Economic Commission for Europe**Inland Transport Committee****World Forum for Harmonization of Vehicle Regulations****Working Party on General Safety Provisions****108th session**

Regulation No. 43 (Safety glazing)**Proposal for amendments to Regulation No. 43 (Safety glazing)****Submitted by the expert from the European Association of Automotive Suppliers^{*}**

The text reproduced below was prepared by the expert from the European Association of Automotive Suppliers (CLEPA) to define a reduced vision zone I for vehicles of categories M and N other than M₁. It is based on informal document GRSG-107-24. The modifications to the current text of Regulation No. 43 are marked in bold characters.

Figure 11

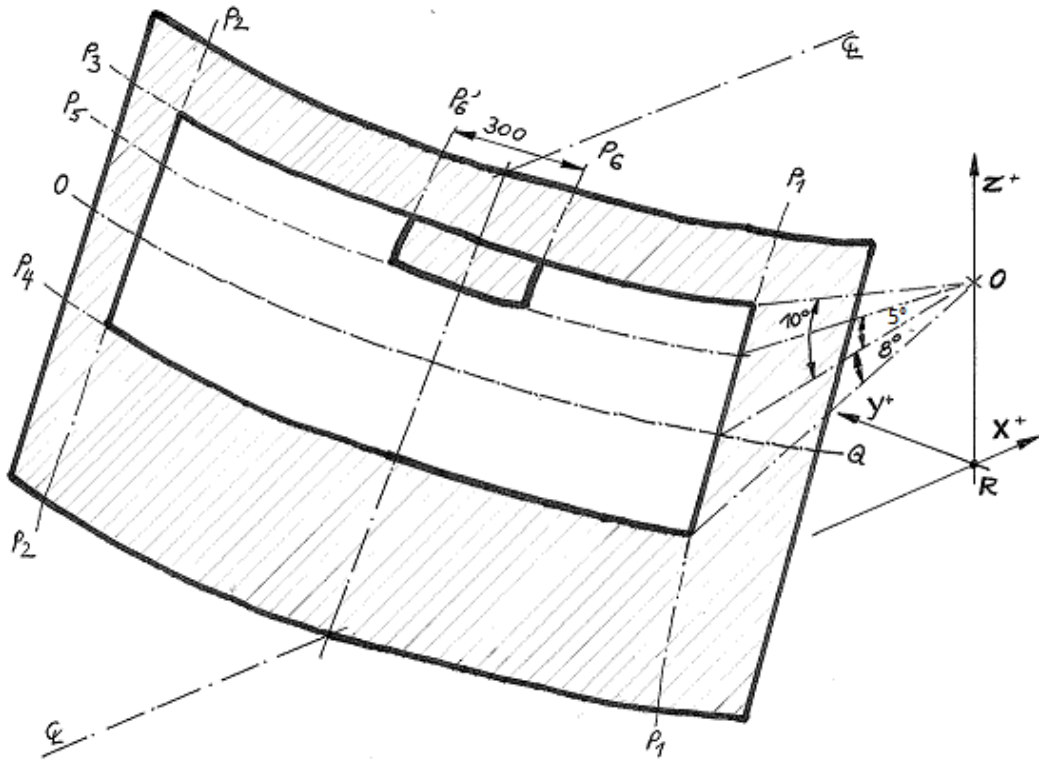
Insert new paragraphs 9.2.5.3. and 9.2.5.3.1., including figure 11 and footnote ⁹, to read:

"9.2.5.3. The reduced test area I is the test area I as defined in paragraph 9.2.5.2.3. with the exclusion of the following area (Figure 11).

9.2.5.3.1. Any opaque obscuration bounded downwards by plane 5, a plane passing through the straight line OQ and forming an angle of 5° above the horizontal plane and laterally by planes 6 and 6', vertical planes parallel to the longitudinal median plane of the vehicle in a distance of 150 mm to the trace of the longitudinal median plane of the vehicle (CL).⁹

⁹ Measured on the outer surface of the windscreen and on the trace of plane 5. If this is not possible (in the absence of a symmetrical median longitudinal plane, for instance) P₆ and P_{6'} shall be the planes parallel to the longitudinal plane of the vehicle passing through point 0."
